Loudon County Solid Waste Disposal Commission
Workshop
March 20th, 2025
4:30PM
Loudon County Annex

RE: Response to: February 19, 2025 Leachate Outbreak Notice at
Matlock Bend Landfill SNL530000203
Loudon County, Tennessee

Subject: Responses to Loudon County Solid Waste Disposal Commission
Comments on the Draft January 2025 Minor Modification – February 19,
2025
Matlock Bend Landfill
Loudon County, Tennessee
SNL530000203
CEC Project 317-474

Figure 1: Leachate Outbreak Location (AOC 1, 2, 3, & 4)

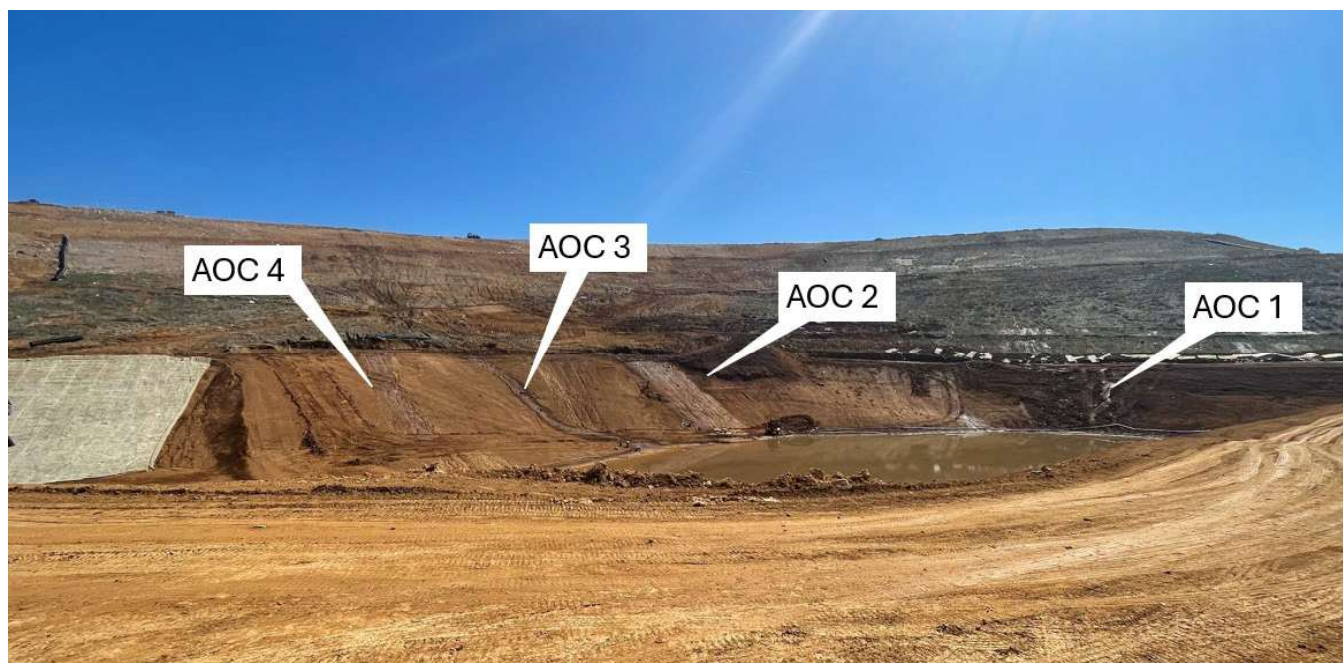
The primary area of concern identified by Republic was a singular leachate outbreak. Based on emails between TDEC and Republic, initial reports identified the cause of the leachate outbreak as undersized pumps (pump failure) and leachate was collected in the sump of Module 2. Reports did not specify the precise location of the outbreak. Upon arriving in the construction area of the proposed new modules, the site representative identified the affected area as the north-facing slope of existing Module A and E, where the plywood is, as the location of the "Self-Reported" Leachate Outbreak. For reporting purposes, this area of concern is AOC 1. According to the findings in Technical Memo February 20, 2025, this area was defined as problematic for "trapping leachate" due to a collapsed pipe or pipe fitting. The collapsed pipe or fitting was identified by Republic in March 15, 2024. In addition to AOC 1, at least 3 other instances of leachate outbreaks were observed along the west-facing slope of Modules B and H (AOC 2, AOC 3, and AOC 4). See the attached site plan for general locations of these AOCs. Figures 1, 2, and 3, below, provide a visual of these AOCs as observed on February 24th.

Figure 5: Leachate Disposal System (Secondary Pumping system)

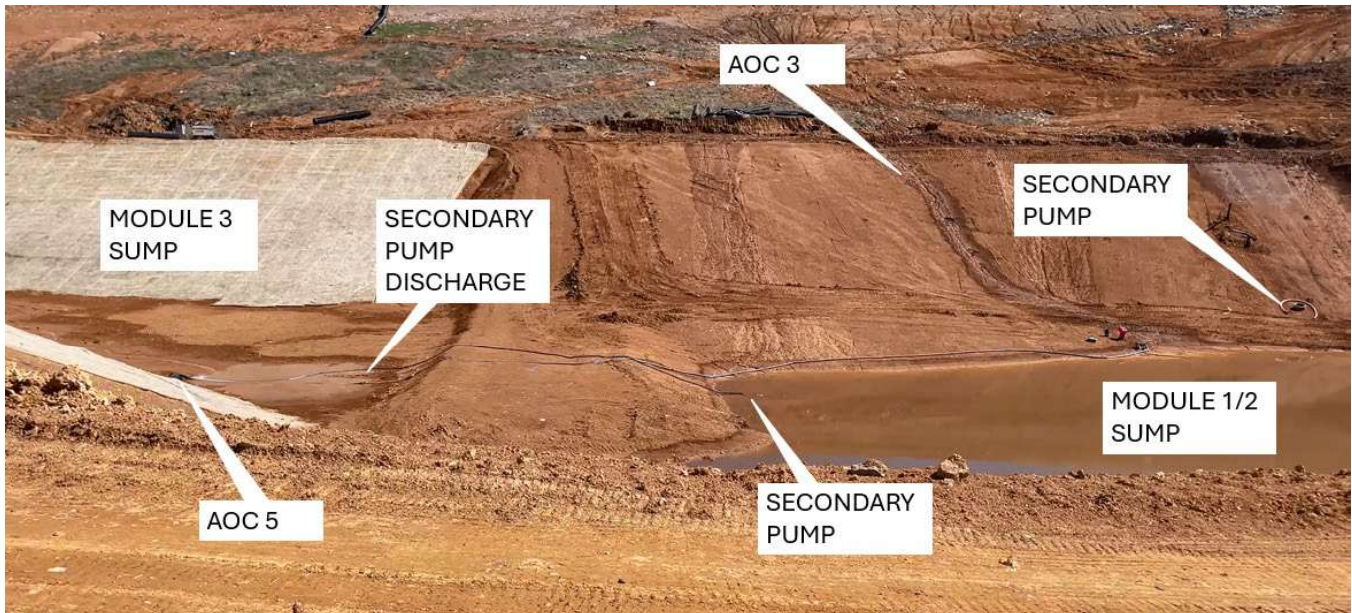
In addition to confirming the presence of the reported pumping system, it was also observed that a secondary pumping system was actively extracting water from the same pool of leachate-laden water and discharging to the north, into proposed module 3 sump. The discharge piping for this secondary pumping system was routed to a pipe that penetrated the bottom of the western berm of newly constructed Module 3 (Figures 5 and 6). Presumably, the drain for the sump of proposed Module 3. At a visibly similar elevation on the opposite side of the berm, an aqueous conveyance was observed along the northwestern side of the access road, in the ditch at the entry to Sediment Pond #3, see Figure 7. With a high degree of certainty, this strongly indicating the presence of a direct pathway of leachate-laden water to sediment pond #3.

Figure 6: Pumping Discharge (AOC 5)

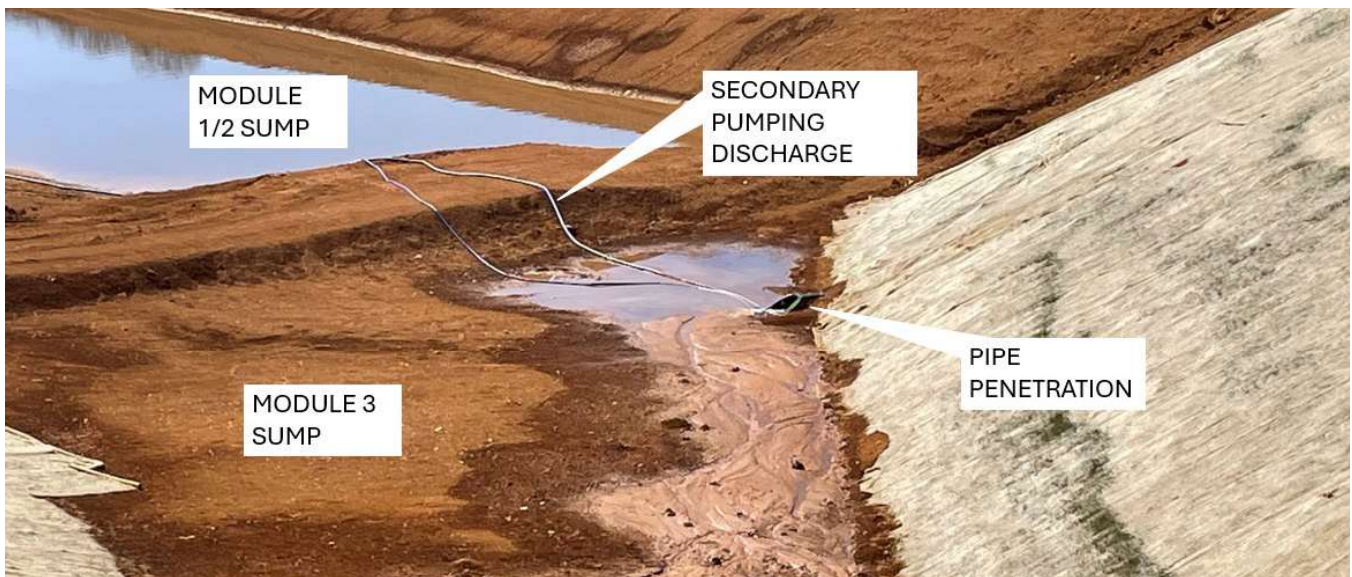
Based on observations and sampling results, there were multiple points of leachate from the active landfill Modules A, E, B, and H (AOC 1, 2, 3, & 4) that drained into the sump of Modules 1 / 2. Leachate was then pumped not only to the sewer system but also off site through the stormwater system and ultimately released offsite. It is recommended that the full extent of contamination be traced and remediation measures be implemented for all affected areas both within and beyond landfill property boundaries. Additionally, it is recommended that the connection between AOC 5 and AOC 6 be assessed, and any necessary repairs be made.

Original information identified a singular leachate outbreak and as part of a plan of action requested by TDEC on February 19, 2025, dewatering activities sent leachate to the Loudon Utility sewer system. Based on observations and sampling results, there were multiple points of leachate from the active landfill Modules A, E, B, and H (AOC 1, 2, 3, & 4) that drained into the sump of Modules 1 / 2. Leachate was then pumped not only to the sewer system but also off site through the stormwater system. Leachate was pumped from the sump of Module 1 / 2 to the pump station and also into the sump of Module 3 (AOC 5). From AOC 5, the leachate drained through a buried conduit, broken or disconnected, to the stormwater Sediment Pond #3 (AOC 6). Leachate was then pumped directly from Sediment Pond #3 to Outfall #3 (AOC 7), and ultimately released offsite. It is recommended that the full extent of contamination be traced and remediation measures be implemented for all affected areas both within and beyond landfill property boundaries. Additionally, it is recommended that the connection between AOC 5 and AOC 6 be assessed, and any necessary repairs be made.

Figure 10: Sediment Pond #3 Outfall (AOC 7)(Woods are off-site)

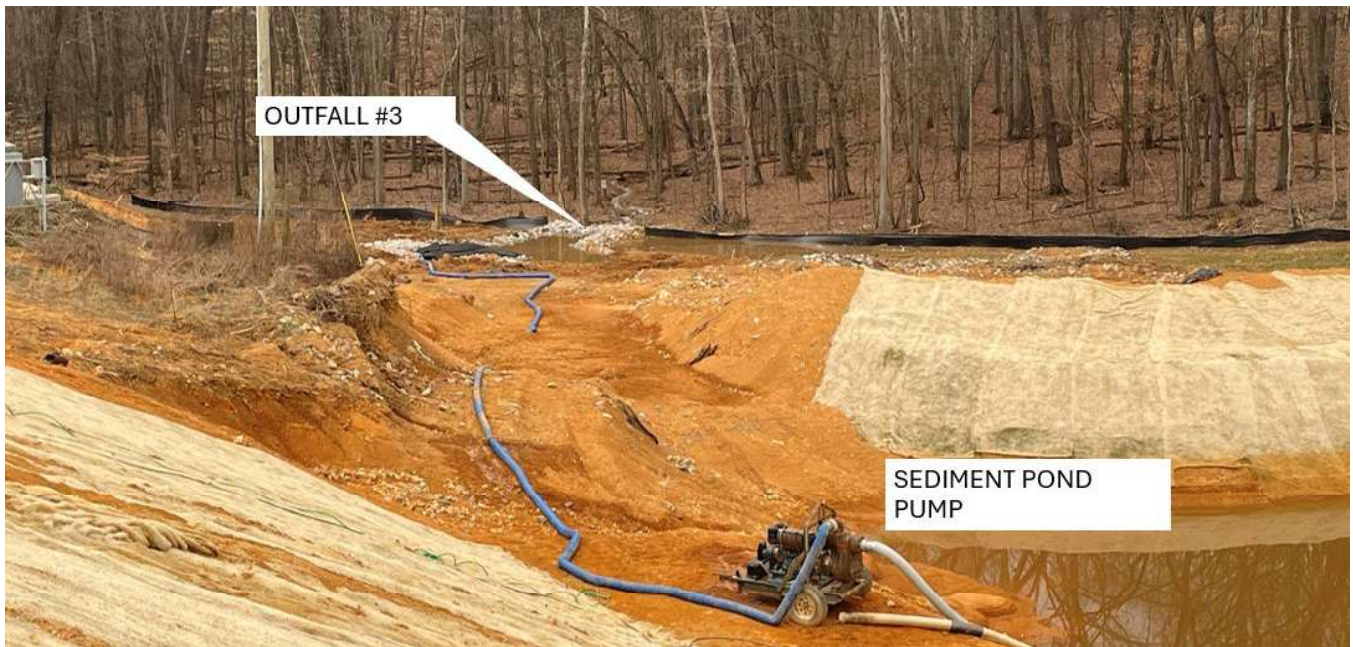
Upon arriving in the construction area of the proposed new modules, areas closest to the source, AOC 1, 2, 3, and 4, had evaporated, the ponding in sumps of Modules 1 / 2 was considerably reduced, and the sump of Module 3 had a noticeable increase in the volume of water, see Figure 8 as compared to Figure 5. All pumps were running similarly to February 24, 2025, and the aqueous conveyance at AOC 6 continued to flow, see Figure 9. A pump was actively drawing out of Sediment Basin #3 near the designed discharge and pumping westward to a sediment bag at the outfall and discharging off site (see Figure 10).
